TEMPORARY CORRECTION T-1(A) TO TECHNICAL MANUAL FOR  
RADIO RECEIVER R-39~~A~~/URR  
NAVSHIPS 93053

This temporary correction revises the manual to reflect the equipment changes made by Field Change 3-R-390A/URR. The purpose of this field change is to alter the electrical access at the rear of the receiver from terminal boards to "AN" type connectors. If it becomes necessary to remove the receiver from its cabinet, it will be necessary only to unfasten connectors instead of the individual wires at the terminal boards. The field change applies to all shipboard R-390A/URR Receivers, all serial numbers.

Figure 1

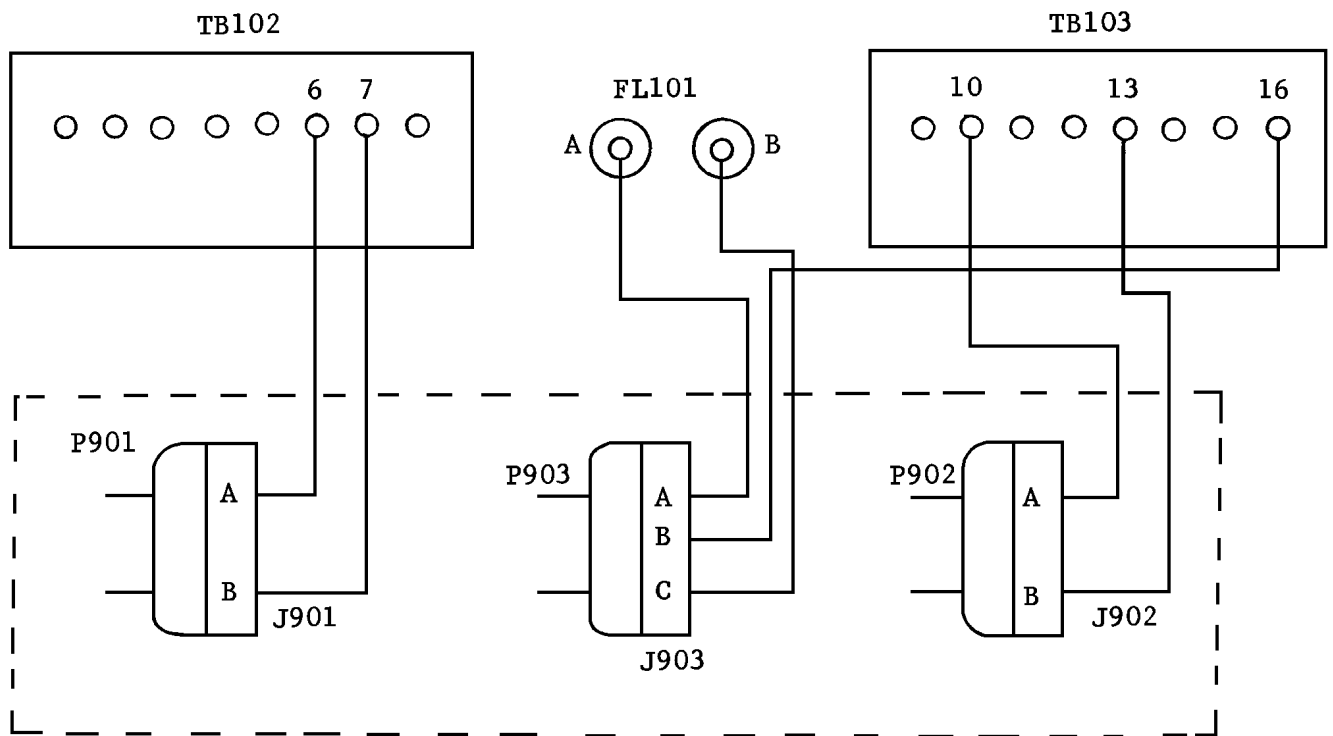
126	Figure 75	Delete "16 GND" and add: "Ground common lead of electronic multimeter at any convenient point on the receiver."
130	Figure 76	Add: "Connections to terminal boards TB102 and TB103 must be made from inside the receiver."
134	Figure 77	Same as Figure 76.
140	Figure 79	Same as Figure 76.
142	Figure 80	Same as Figure 76.
178	Figure 89 (Sheet 1)	Change Fig. 89, sheet 1, to show AC input power in accordance with Figure 1 center drawing of T-1(A) NAVSHIPS 93053.
179	Figure 89	Change Fig. 89, sheet 2, to show audio output in accordance with Fig. 1 of T-1(A) NAVSHIPS 93053.

J901 is MS3102A10SL-4P  
 J902 same as J901  
 J903 is MS3102A16S-5P

P901 is MS3108B-10SL-4S or MS3106B-10SL-4S  
 P902 same as P901  
 P903 is MS3108B-16S-5S or MS3106-B-16S-5S

P901-P902 have Cable Clamp MS3057-4  
 P903 has Cable Clamp MS3057-8
